REMARKS

AMENDMENTS TO THE DRAWINGS

FIG. 1

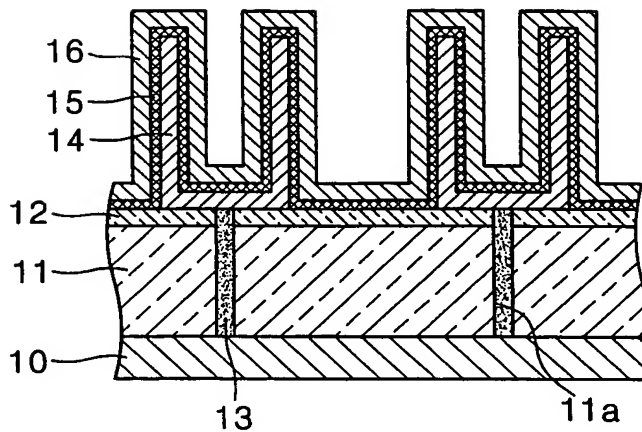
In the outstanding Office action, the Examiner objected to the drawings, FIGS 1-3E, as described in applicants' disclosure paragraphs [0003]-[0020], which should be designated by a legend such as – Prior Art –. Applicants amended FIGS. 1 – 3E to include a legend “RELATED ART.” It is respectfully requested that the objection be withdrawn.

Attached hereto is a Replacement Drawing Sheet, including original FIGS. 1, 2 and 3A – 3E. FIGS. 1, 2 and 3A – 3E are amended to include a legend “RELATED ART” responsive to the objection to the drawings. Entry of the Replacement Drawing Sheets and removal of the objection to the Drawings are respectfully requested.
